Project Advisory Committee (PAC) - Meeting #1 Meeting Summary

On March 20, 2017 the City of Hillsboro Parks & Recreation Project Team met with the Project Advisory Committee (PAC) for the Crescent Park Greenway Trail Plan. The PAC was selected to provide perspective and expertise from a broad range of stakeholders, community advisory boards and professional staff. Members were either appointed by their respective agency or through a formal request at board meetings.

PAC Meeting # 1 Summary

South Hillsboro Area 9 - Trail Alignment

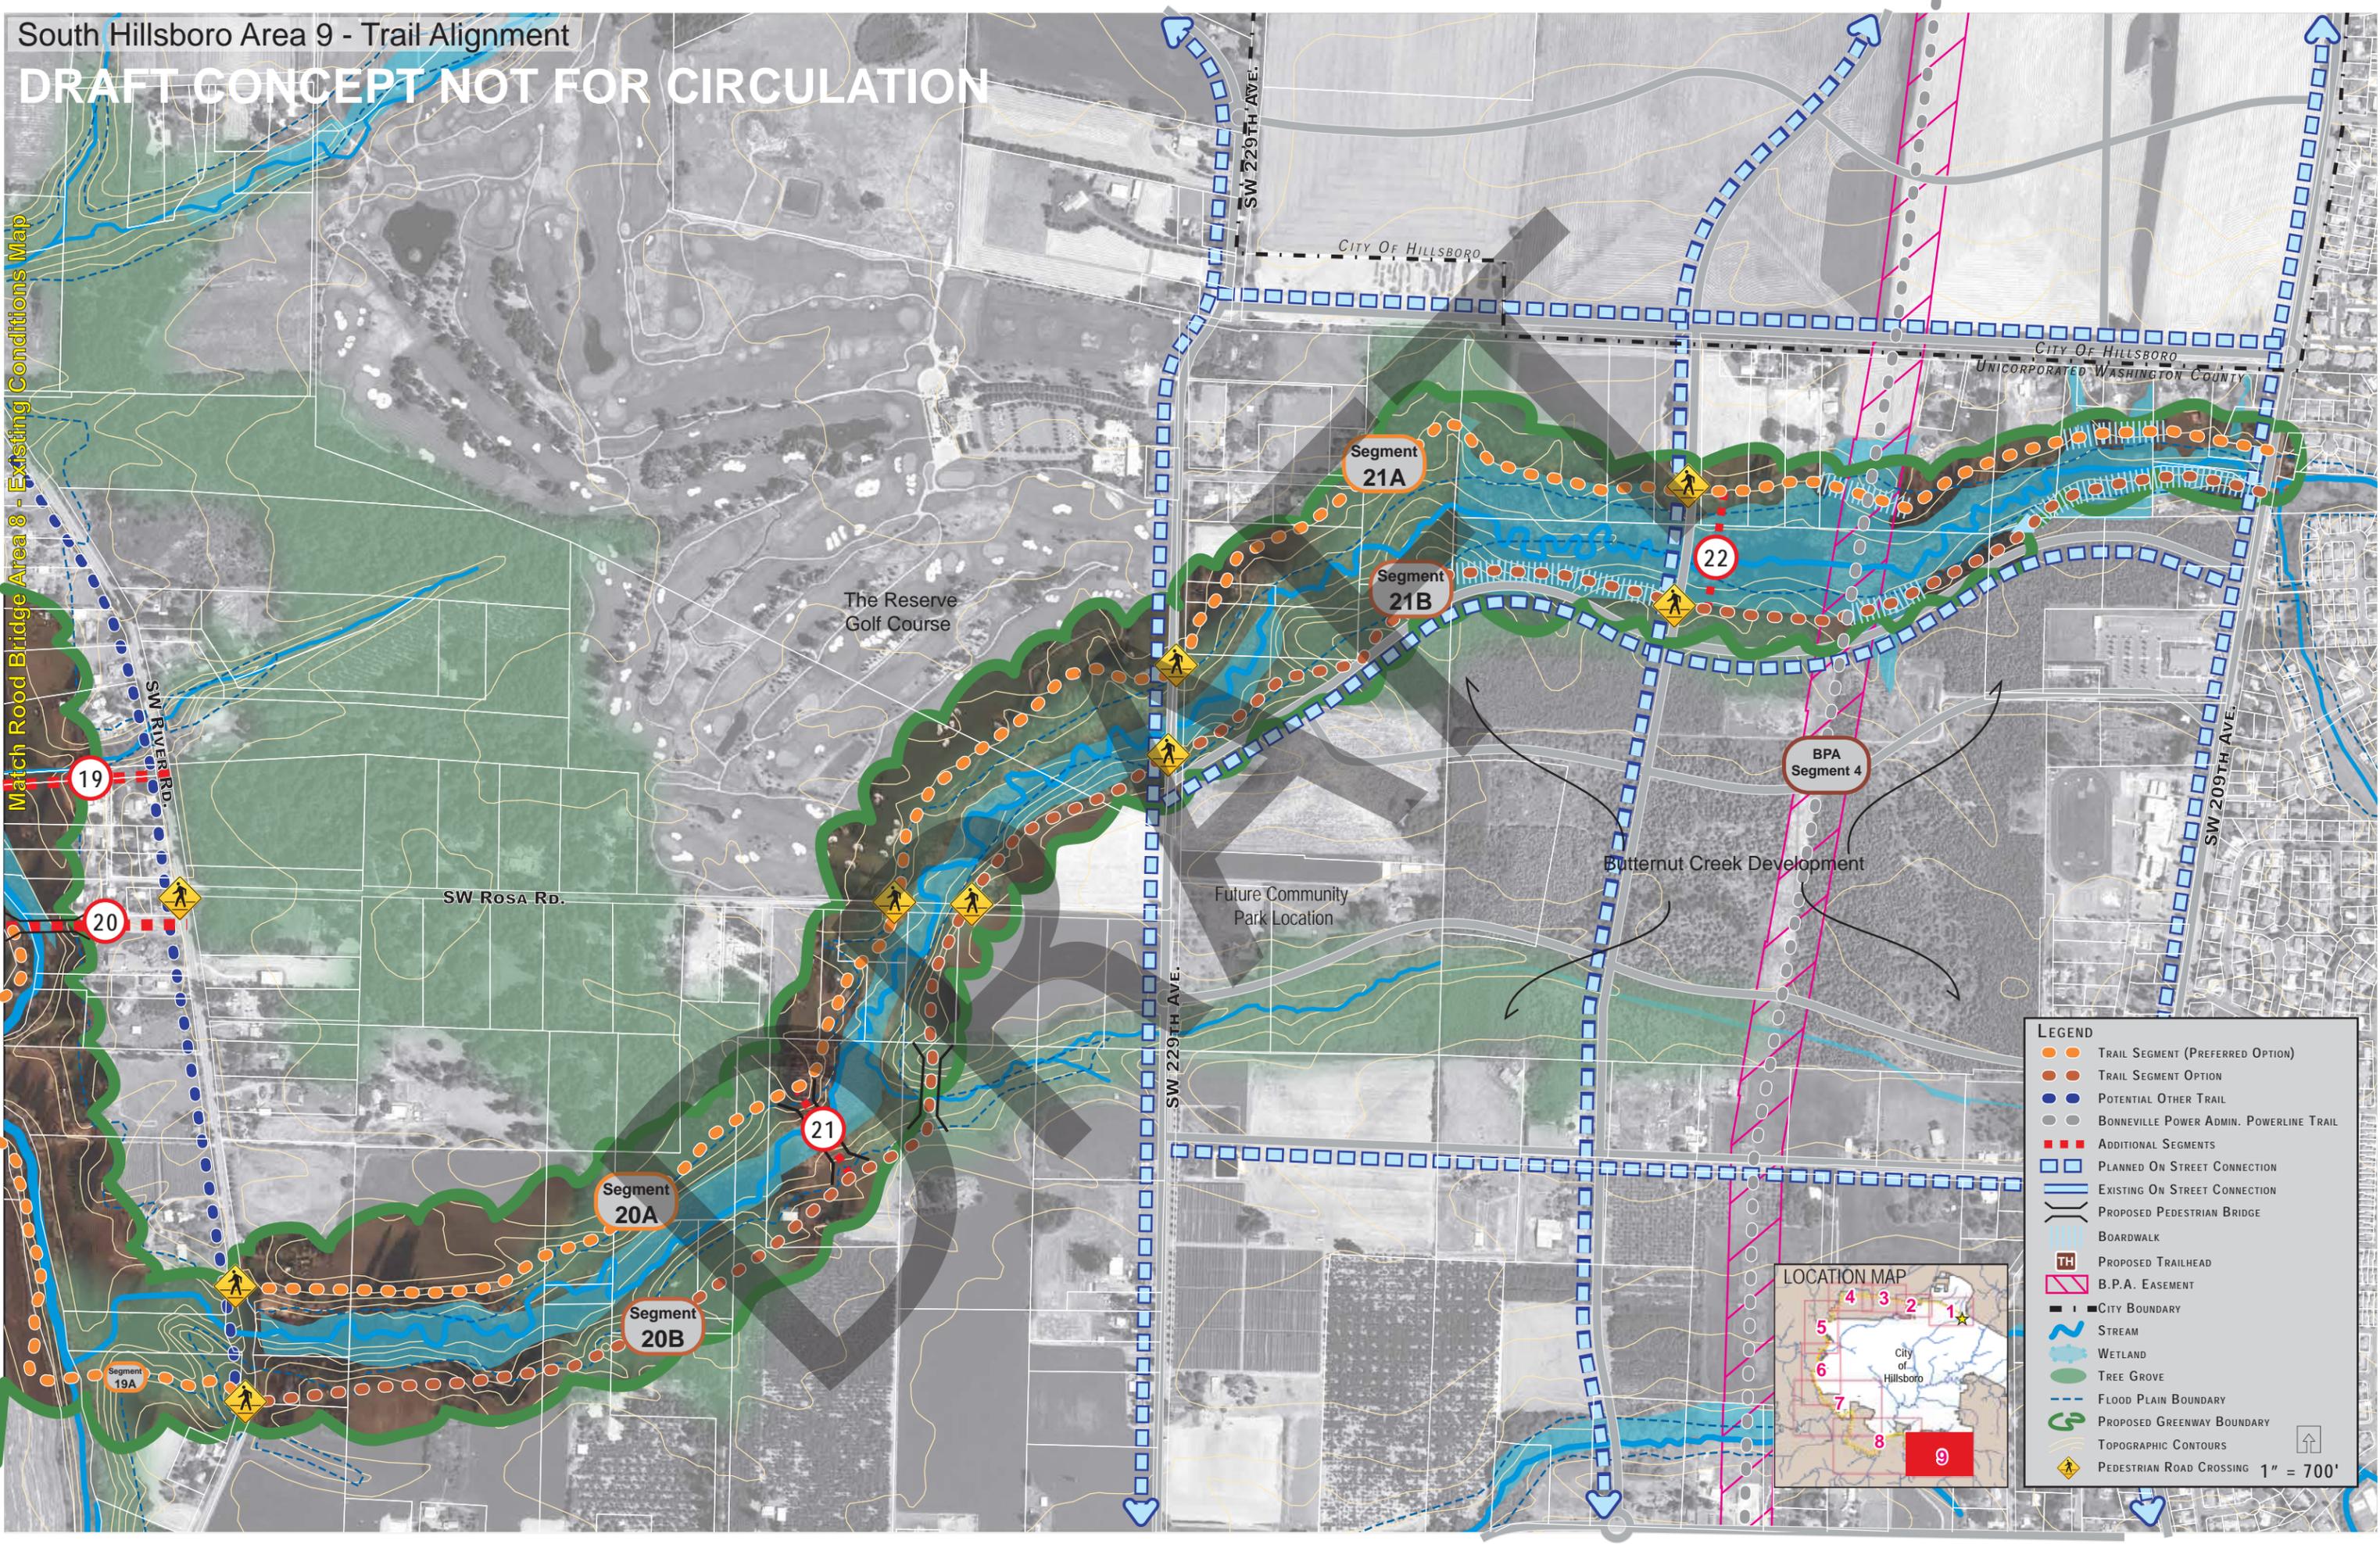
- Show River Road trail connection (as discussed in Area 8).
